ISLAND AVENUE
109B-D-26-28

CLIFF ISLAND

(3) LIMITED BUSINESS ZONE PERMIT ISSUED
APPLICATION FOR PERMIT Permit No. **0069**

Ward 1 Permit No. 33/527
 Loc. ~~at~~ ^{Clifford Ave} ~~at~~ ^{Clifford}
 Owner: Susan S Mac Lane
 Date of permit 5/12/33
 Nos. closing-in _____
 Inspn. closing-in 109-D-21
 Final Notif. _____
 Final Inspn. 9/7/34 CDB
 Cert. of Occupancy issued ~~None~~

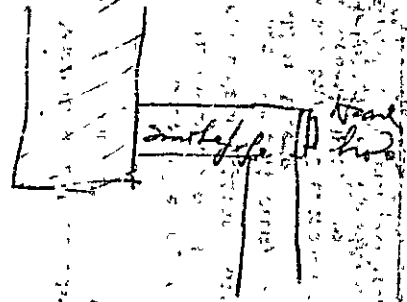
8/7/33. NOTES
 Concrete foundation
 in place of stone
 brackets to support
 chimney were omitted
 and rods added. Could
 not see this construction
 but saw the Union is
 satisfied as to strength
 of this support & support
 in way to get above
 2' from the about
 distance from ceiling to
 where this chimney is
 stopped off. The cleanout
 was left out of joint or
 this would come about
 opposite the semi-circular
 opening which is now
 about the required
 distance below the ceiling

8/22/33 - Better - wind
 7/24/33 - Mr. Mac Lane
 in and I told
 him he could see
 on hand like
 cleanout in
 smoke pipe
 like this

9/9/34.
 Cleanout not put in.
 Although he has the smother
 attached above on hand
 he does not seem inclined
 to use. Said he would
 fix it in the first time
 he had to clean the
 chimney out. etc.
